Our Reference: 0178462_RESPONSE TO FURTHER INFORMATION REQUEST_APRIL2016.DOCX

RE: BIALA WIND FARM - REQUEST FOR FURTHER INFORMATION

I refer to the Department of Planning & Environment (DPE) request to Newtricity, as the Proponent of the Biala Wind Farm Project (SSD 13_6039), seeking further information relating to the environmental assessment of the Project as outlined in your email of 29 March 2016 and discussed at our meeting of 8 April 2016, and subsequent email requests of 31 May, and 2 and 10 June 2016 (copies attached in *Annex A*). Outlined below is our response to your queries and additional information as requested.

GUNNING BIALLA
NEWTRICITY OPTIONS
DIAGRAM

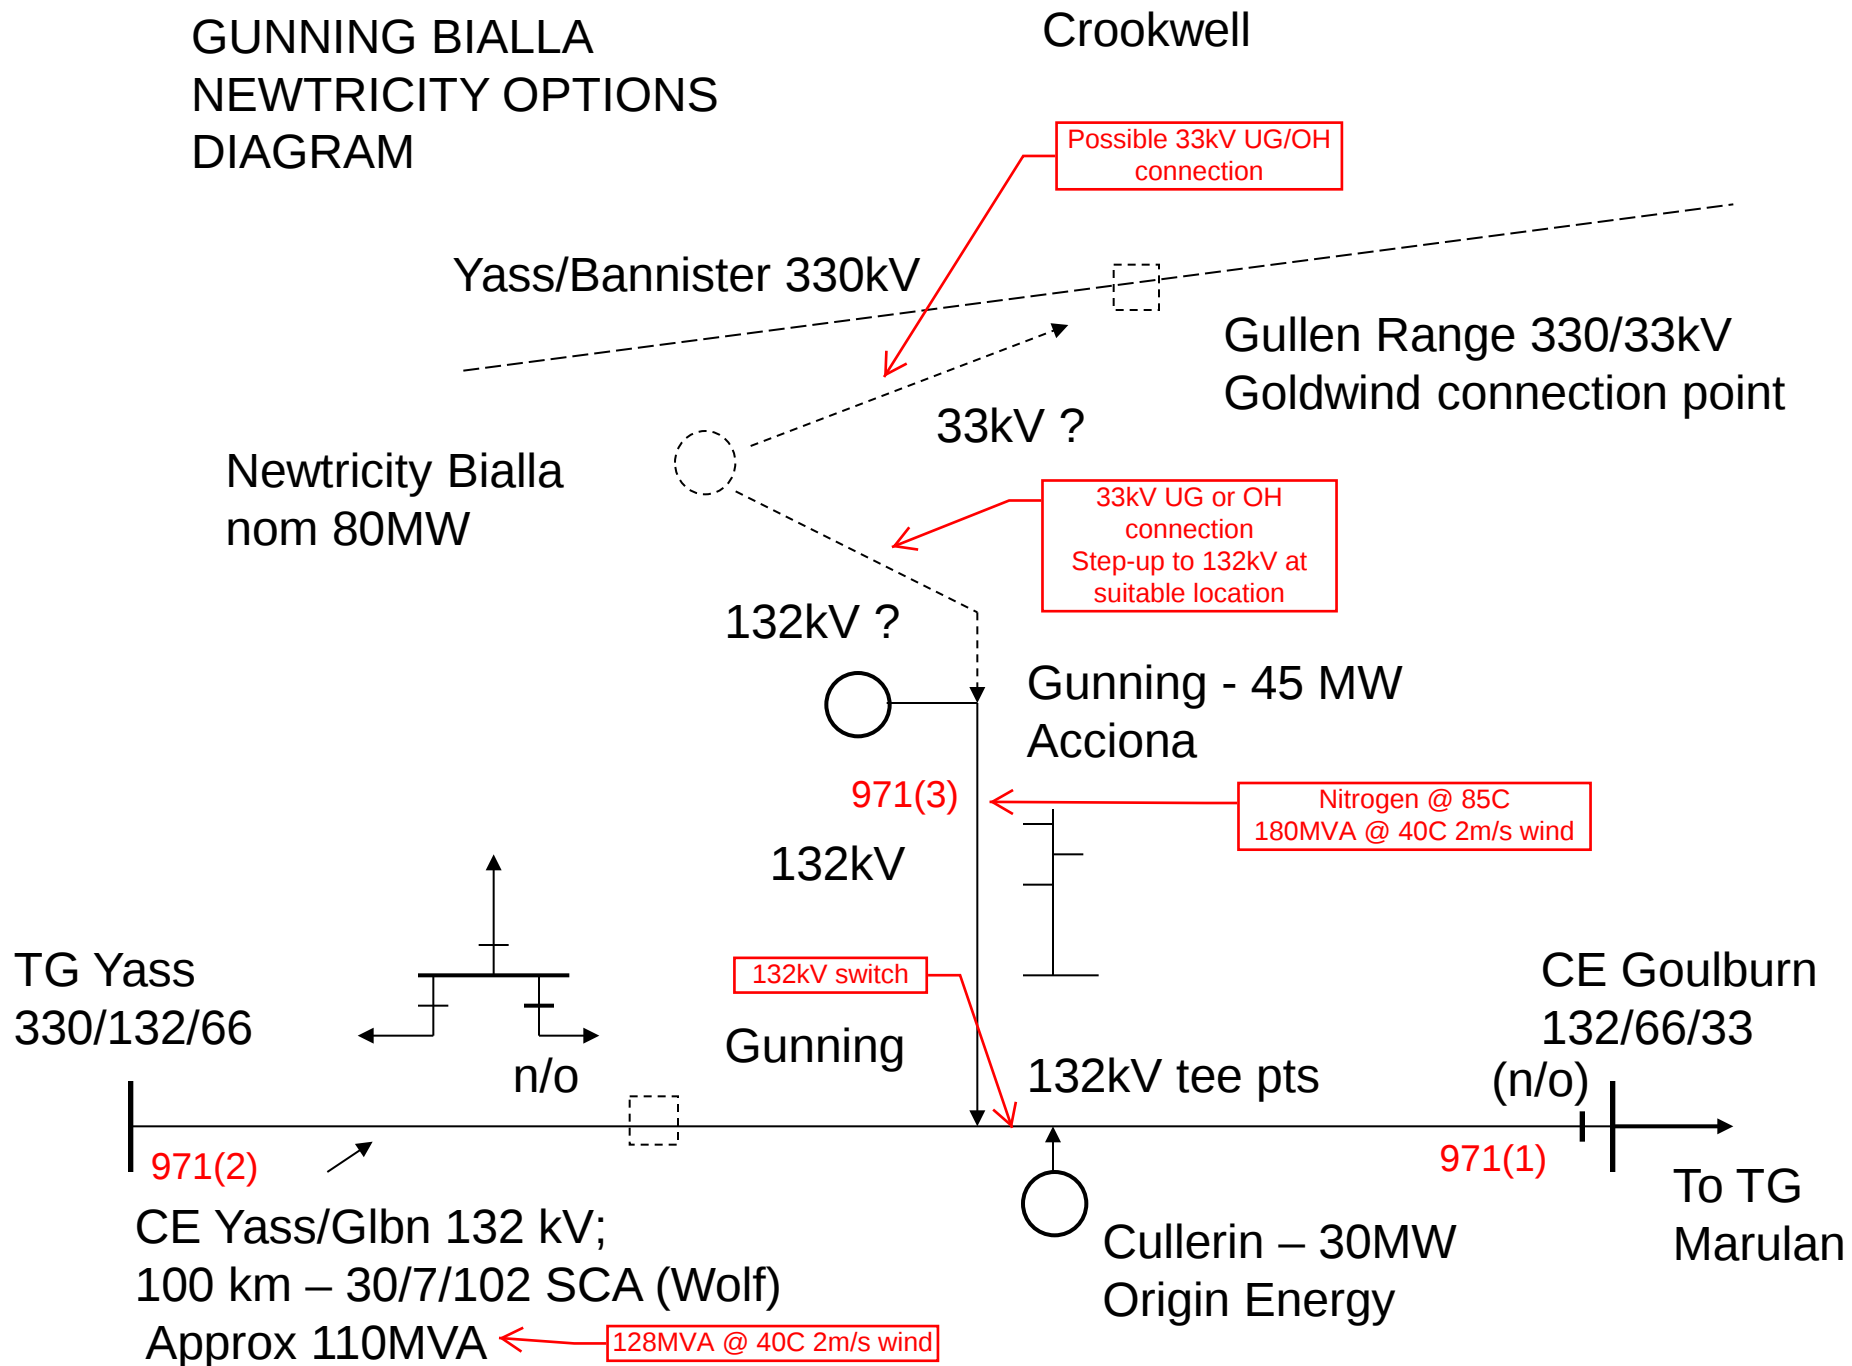
Notwithstanding that the transmission line connection from the Project to the existing electricity network will be pursued separately under Part 5 of the *Environmental Planning & Assessment Act 1979* (EP&A Act), DPE has requested additional information regarding the transmission line connection options for the Project in order to demonstrate that there is a feasible transmission line connection available for the Project. Outlined below is a brief summary of the current connection options under consideration.

Each connection point option is discussed in the sections following, and illustrated in the schematic included in *Annex D*. For each connection option, both underground or overhead transmission line connection options (or a combination of both) are being explored, which are discussed in *Section 5.3*.
